**COUNTY OF WESTCHESTER
NEW YORK**

ADDENDUM NO. 1

CONTRACT NO. 19-514

**Low Rise Building Renovations and HVAC Improvements
110 Dr. Martin Luther King Jr. Boulevard
White Plains, New York**

PARTIAL DEMOLITION PLAN - CENTRAL

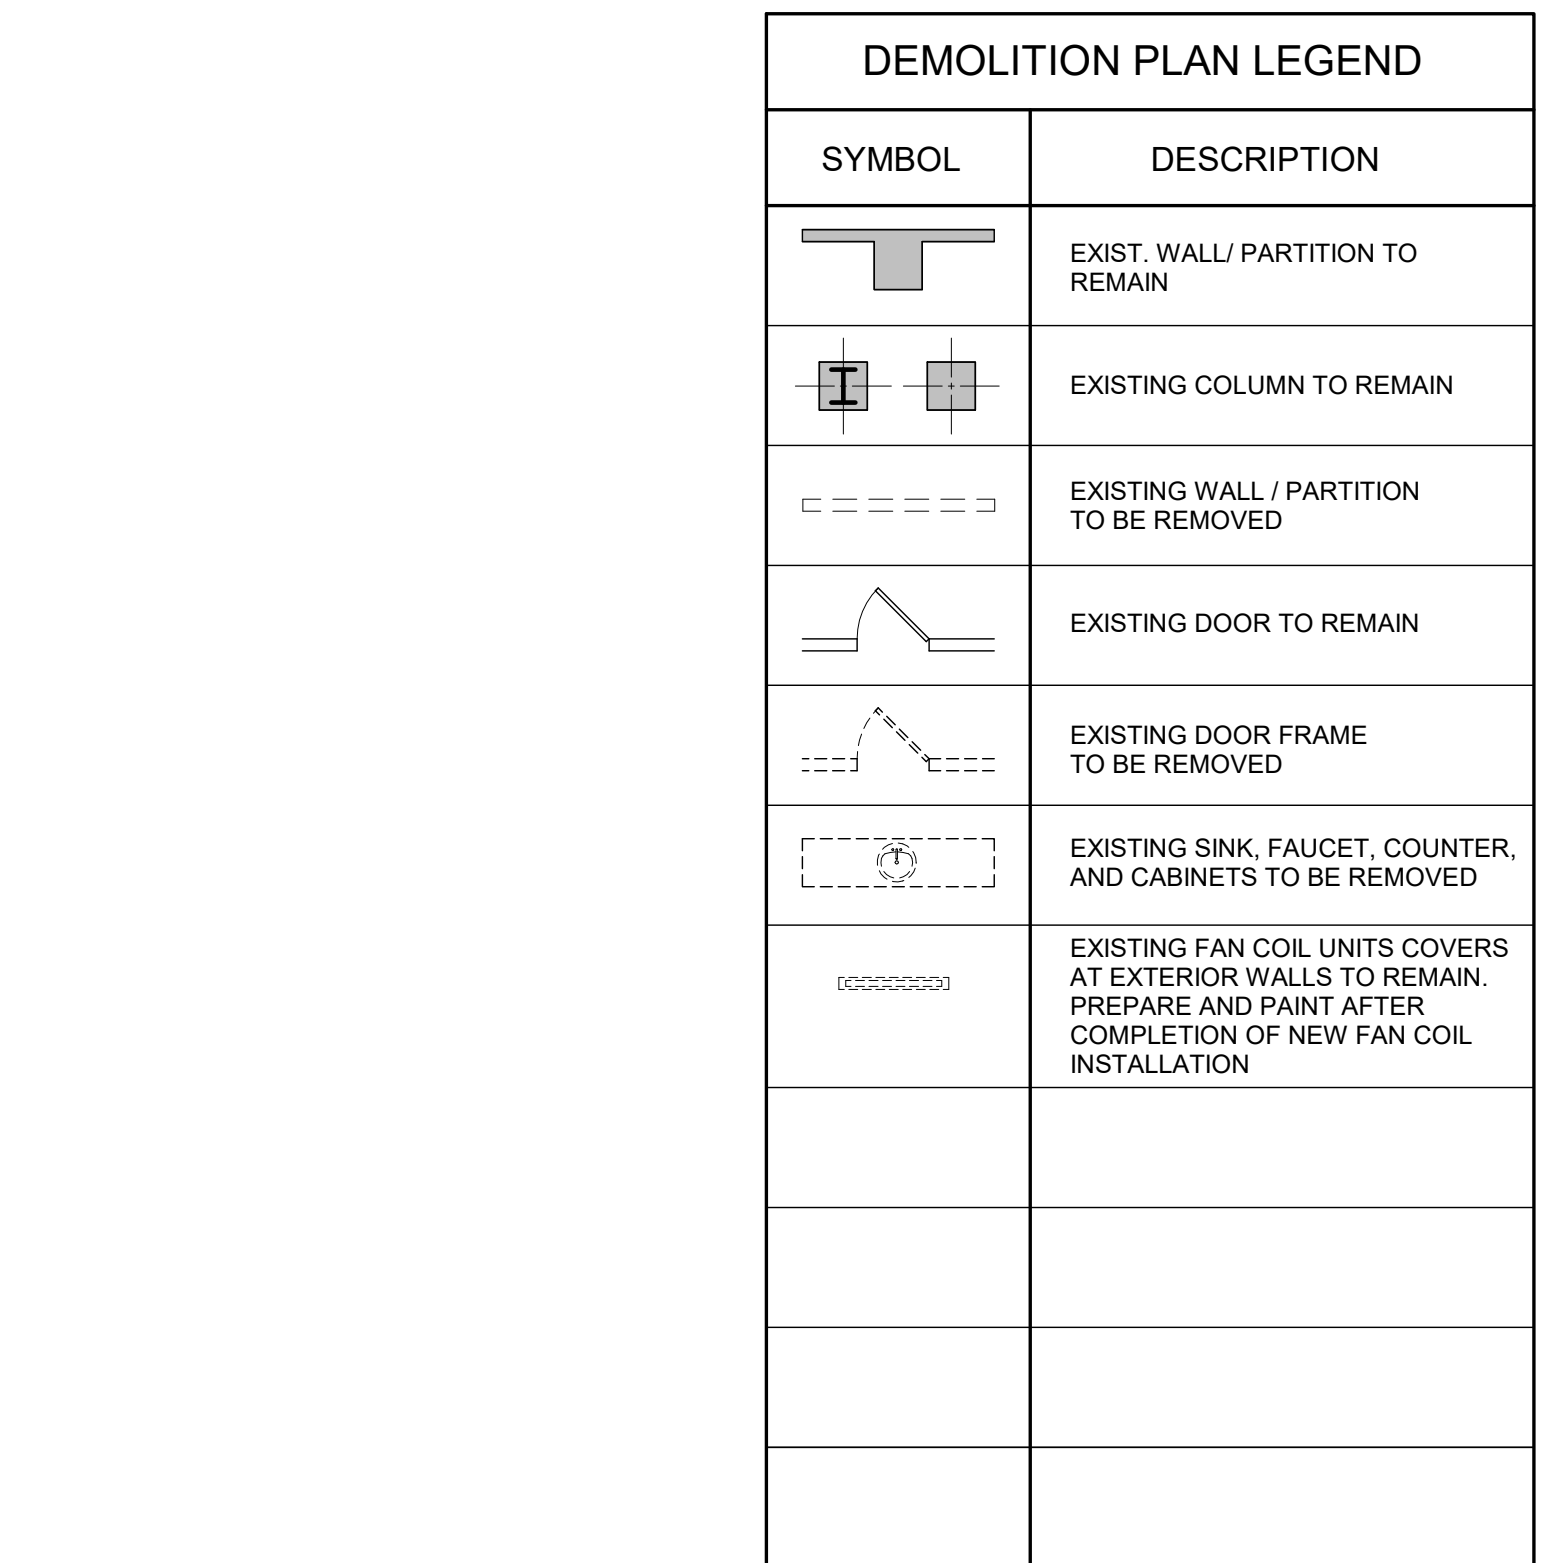
B. Furniture Demolition – Revised Drawings: Demolition of all existing furniture, shelves, counters, millwork, etc. is by the contractor. The demolition drawings DM-002, DM-003 and DM-004 have been revised to provide a general description of the principal furniture items. Personal effects, computers, etc. at the work positions are not to be demolished, and are to be moved by the contractor from their existing locations to their final locations, in accordance with the Phasing Plans.
